Summary for DRH19-00057

Patrick McKeegan – PMA, Inc. requests Design Review approval to construct a 6,196 square foot, single-story restaurant building with associated site improvements in a C-2D (General Commercial with Design Review Overlay) zone

Planning Division Project Report

File Number	DRH19-00057
Applicant	Patrick McKeegan / PMA, Inc.
Property Address	4620 W Overland Road
Public Hearing Date	March 13, 2019
Heard by	Design Review Committee
Design Review Planner	Katelyn B. Menuge
Design Review Supervisor	Josh G. Wilson

LANDSCAPE PLAN

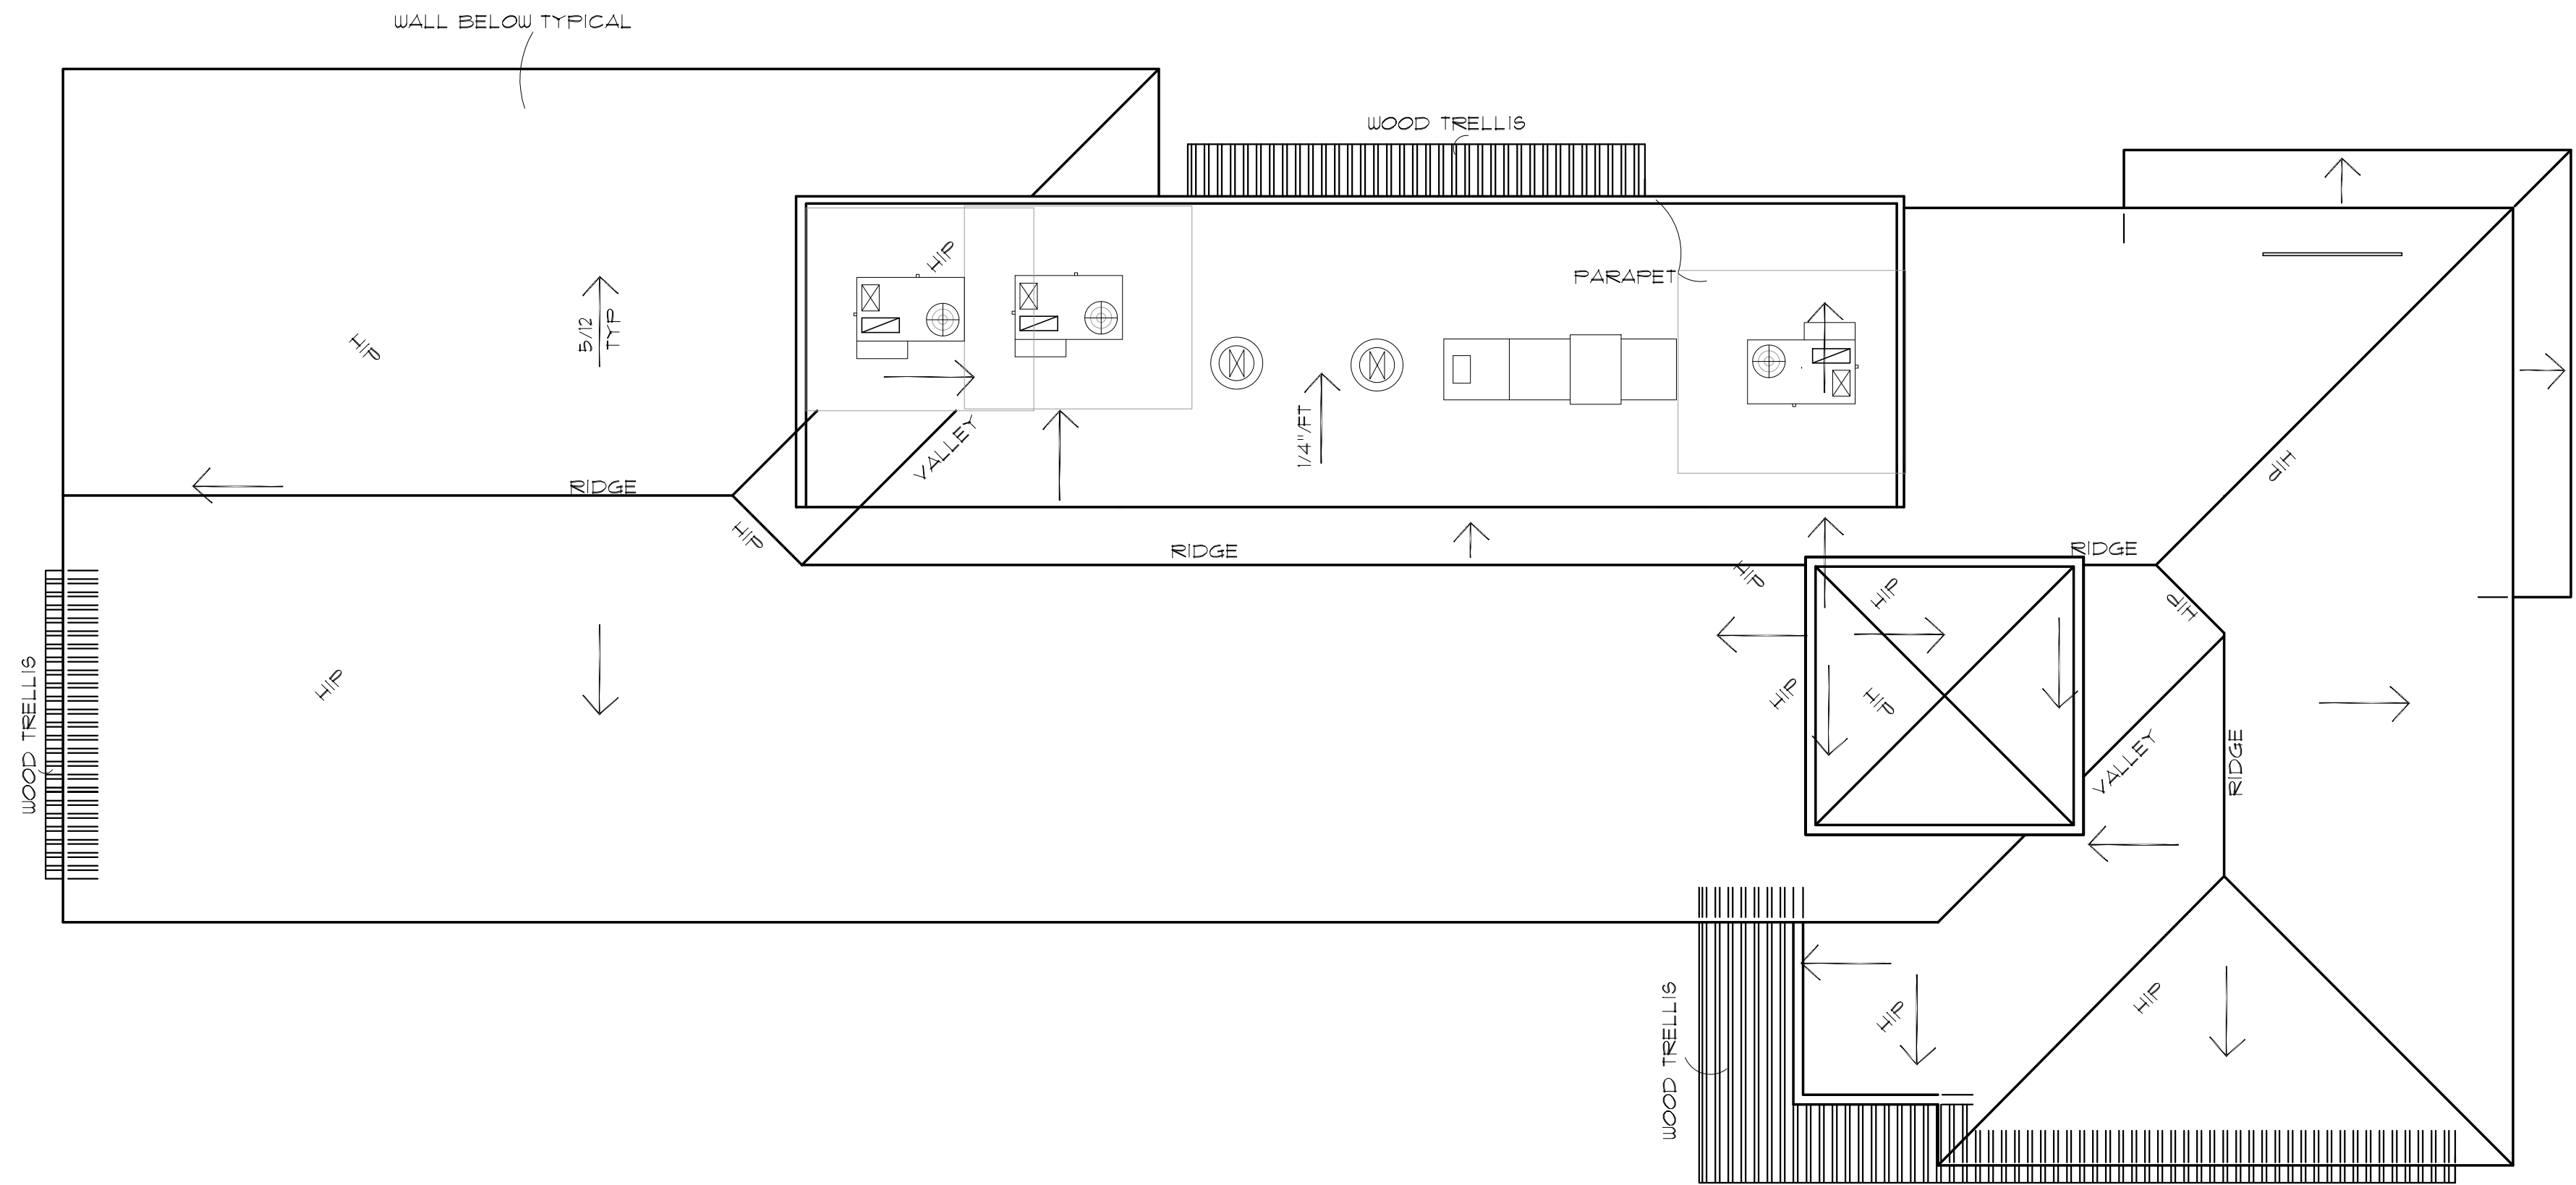
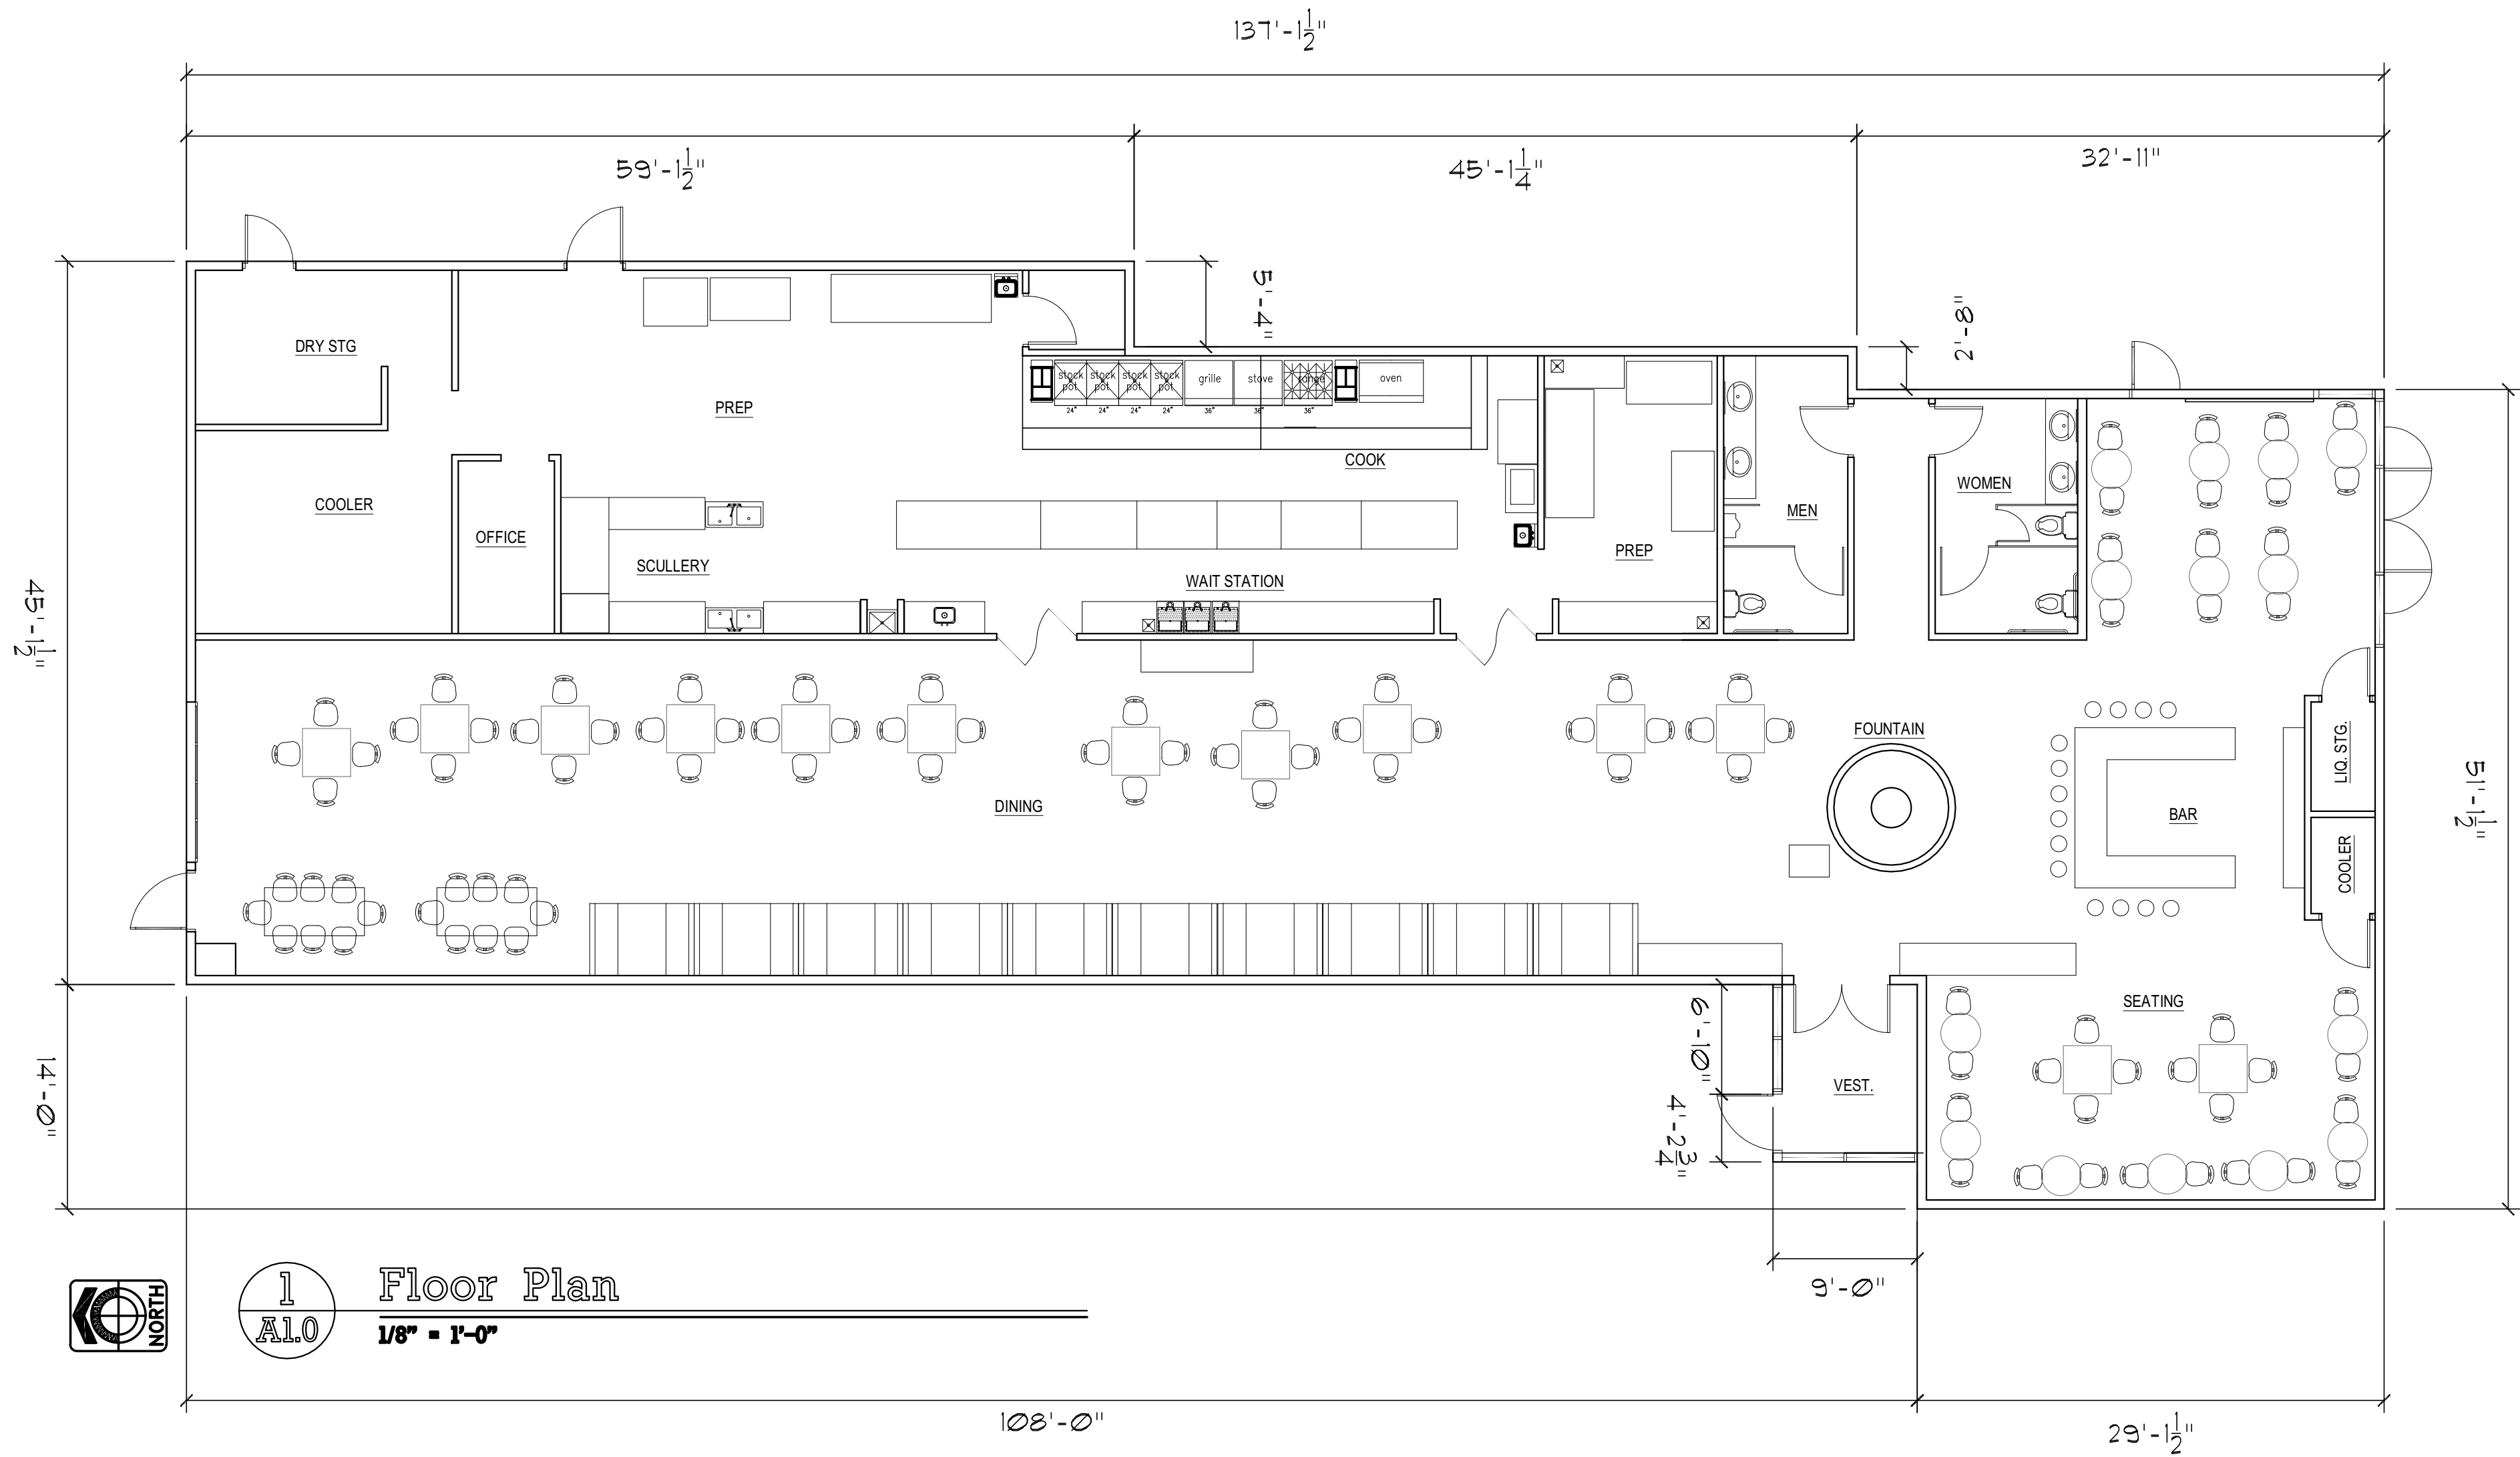
The existing evergreen trees at the rear of the property are proposed to be removed and updated with low growing vegetation and Class II deciduous trees. If this area is within 10 lateral feet of overhead powerlines, the applicant should instead utilize Class I trees. This rear landscape area should also be enlarged to provide the full 10-foot setback, or a variance be obtained.

The applicant is requesting Alternative Landscape Compliance to not install two of the required landscape islands at the south ends of the parking rows, adjacent to the street, a terminal landscape planter at the west of the rear parking row, and a terminal landscape planter at the south end of the east parking row. The required drive aisles to provide cross-access utilize a large area, creating space limitations. As the applicant is in need of additional parking and is providing new landscaping along the street with additional shrubs for screening, numerous interior landscape planters and is updating the rear landscape buffer, staff feels the applicant has met the intent of the code to break up large expanses of paved surface and provide an attractive streetscape, and screen parking from the street and residential properties.

- g. Replace the proposed Autumn Purple Ash trees with another approved Class II tree species, such as Littleleaf or American Lindens.
 - h. Exterior lighting fixtures shall be full-cutoff and directed downward. Light poles shall be located outside of required landscape planters. Any outside lighting shall be reflected away from adjacent property and streets. Exterior light fixture details shall be submitted to the Design Review staff for approval prior

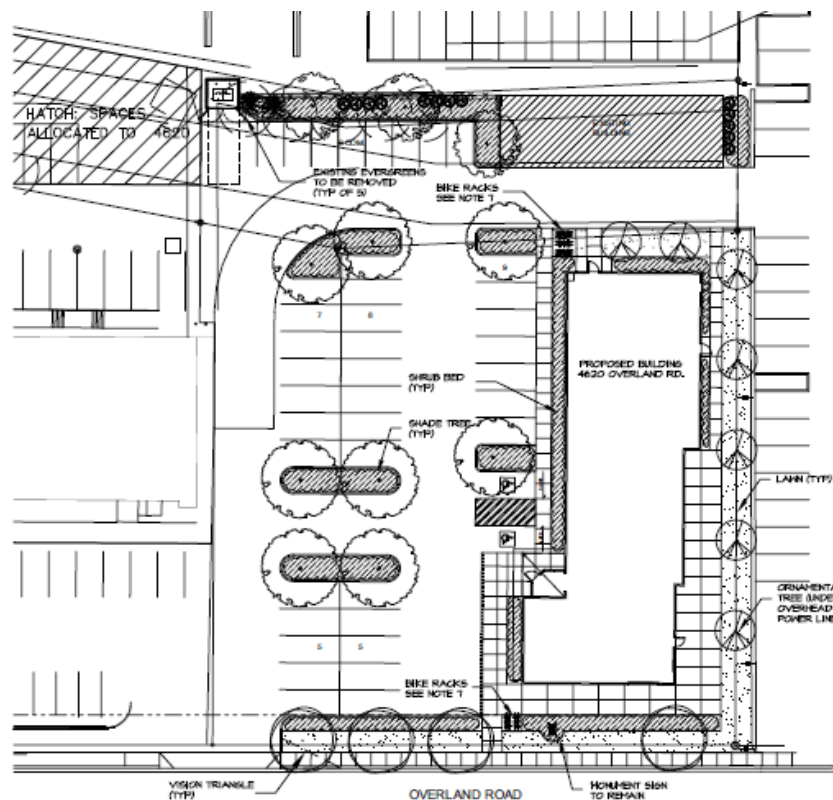
The applicant has placed the parking area to the west side of the site, and the new building along the east side of the site. The building is proposed to have 243 seats, requiring a minimum of 81 seats. The applicant is proposing to provide 42 parking spaces on the site, and request 39 spaces be shared with the adjoining properties. The applicant has indicated there is an existing shared parking agreement that

allows the applicant to utilize the 39 spaces. The applicant shall provide a copy of that document or obtain and record new shared parking and cross-access agreements. A joint parking application may be required prior to building permit submittal. Alternatively, the applicant can provide all the required parking on the site or obtain approval for a parking reduction.

- a. Submit the existing cross-access and shared parking agreements, providing all required parking for each building, or record and submit new agreements prior to building permit submittal. A joint parking application may be required prior to building permit submittal. Alternatively, the applicant can provide all the required parking on the site or obtain approval for a parking reduction.

- b. Relocate the rear parking and solid waste enclosure to be outside of the 10-foot rear setback or obtain a variance approval.
 - c. Provide a minimum of 9 bicycle parking spaces on the site, one per every 10 required parking spaces. Bicycle parking shall meet all dimensional requirements of the Zoning Ordinance.

South (Overland Rd) Elevation

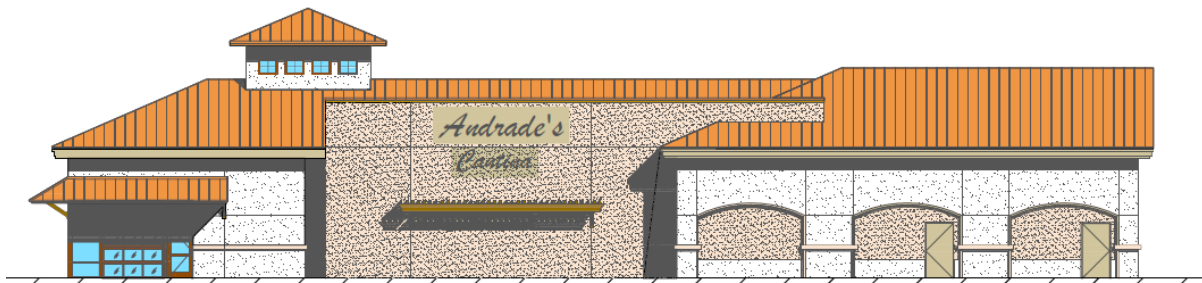
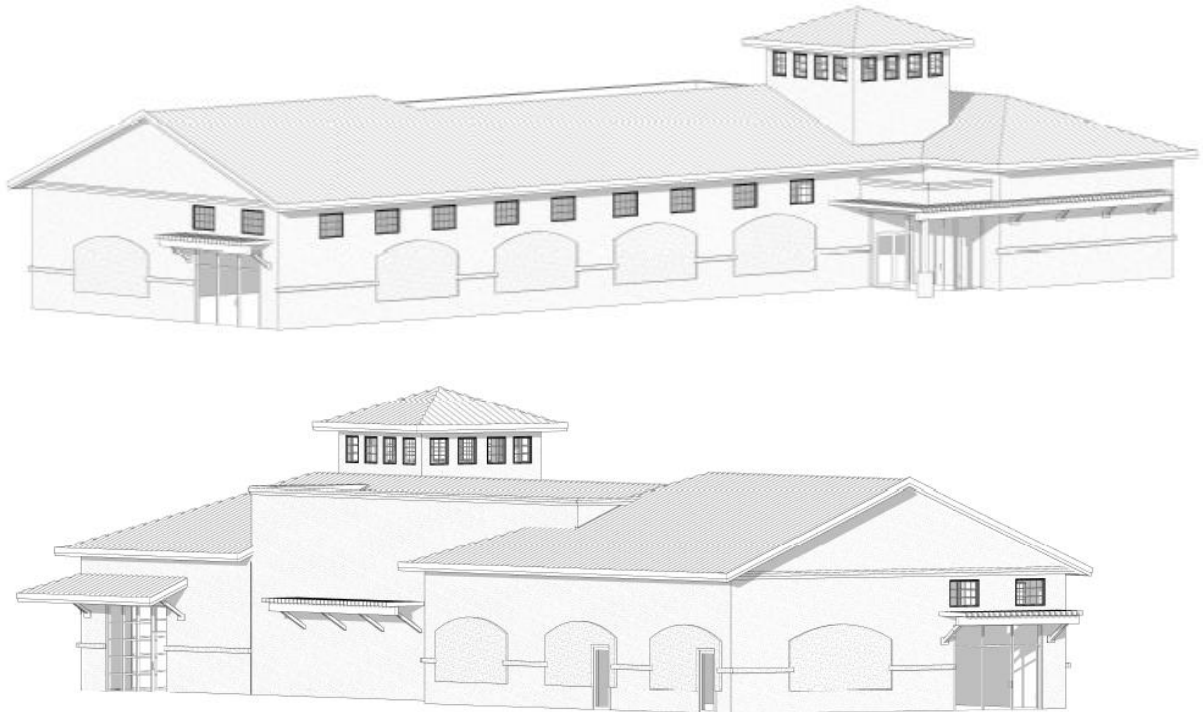
The applicant is proposing to place the main entry door on the west side of the building, with a pedestrian path and large trellis highlighting the entrance location. Another door on the front façade accesses the front outdoor patio seating area. The applicant has provided roof overhangs and the large trellis elements that will create additional interest and shadow lines. Recessed arches are utilized along the east and west elevations, that add interest and remove the appearance of any blank walls. The required material change along the base of the building will also add additional façade interest. This portion of Overland has a Commercial/Mixed-Use Block Frontage designation, which requires 25-40% of the ground level façade between 4-8 feet above the sidewalk to utilize windows/transparency. Staff has calculated that the applicant's front storefront system comprises approximately 30% of this area, complying with the standard.

- d. Replace stucco with concrete, masonry, or other durable material for wall surfaces within two feet of grade when adjacent to a public sidewalk, internal pathways, or drive aisles, to provide a durable surface where damage is most likely. A maximum of 50% of the front, Overland-facing façade area shall utilize stucco.
